Office Action Summary

10/688,365

FORSBERG, ANDREW THOMAS

DETAILED ACTION

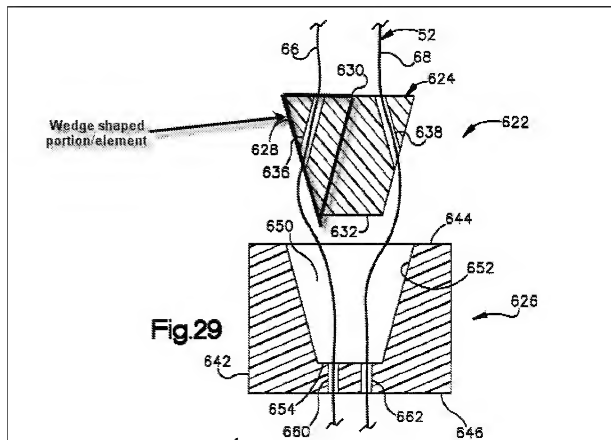
In addition, Bonutti et al teaches a system comprising: a housing (626), a channel (636 and 660); and a suture locking mechanism including a wedge shaped portion/element (see Figure below and Col. 32, lines 25-29, wedge is defined to be "any shape that is triangular in cross section" or "a piece of anything of like shape"); wherein the locking mechanism changes from the non-locking position to the locking position by sliding movement (Col. 32, lines 30-67); wherein the wedge shaped portion of the locking mechanism is spaced apart from the housing (Fig. 29); wherein wedge shaped

portion of the locking mechanism is in engagement with the housing (Col. 32, lines 30-67); wherein the wedge shaped portion of the locking mechanism includes a planar surface (632); wherein the suture locking mechanism comprises at least one channel (636 and 660) through the housing; wherein the at least one channel is arranged such that it provides a substantially non-tortuous suture path when the suture locking mechanism is in the non-locking position (Fig. 29); and the at least one channel is arranged such that it provides a substantially tortuous suture path when the suture locking mechanism is in the locked position (Fig. 29); wherein the non-tortuous path is substantially parallel to the suture and the tortuous path has at least a portion that is substantially non-parallel to the suture (Fig. 29); wherein the channel is substantially straight (Fig. 29); wherein the channel has at least one bend (Fig. 26); wherein the locking mechanism is triangular shaped (see Figure below); wherein the locking member includes at least three exterior surfaces (628, 630, and 632); wherein the locking mechanism includes at least one exterior surface (632) arranged for engagement by the suture (Fig. 29); wherein the suture locking mechanism comprises at least one pair of mating surface (628 and 652 or 632 and 654); wherein the channel comprises: a wide end and a narrow end (636 comprises a wide end on the bottom and a narrow end on the top); and at least one curve (Fig. 26); wherein the narrow end comprises a notched surface (684, Fig. 31); wherein the locking element comprises a bio-resorbable material (Col. 32, lines 11-12); wherein the housing comprises at least a first hole (650) corresponding to the first position and at least a second hole (662) corresponding to the second position; the locking device or inner housing assembly

comprises at least a tab (1504); wherein the housing comprises sidewalls (Fig. 29), such that sidewalls provide angle inwards from at least the first hole to at least the second hole; wherein the inward slope of the sidewalls provides a compressive force on the locking device tending to cause the plurality of mating surfaces to move toward each other (Fig. 29)
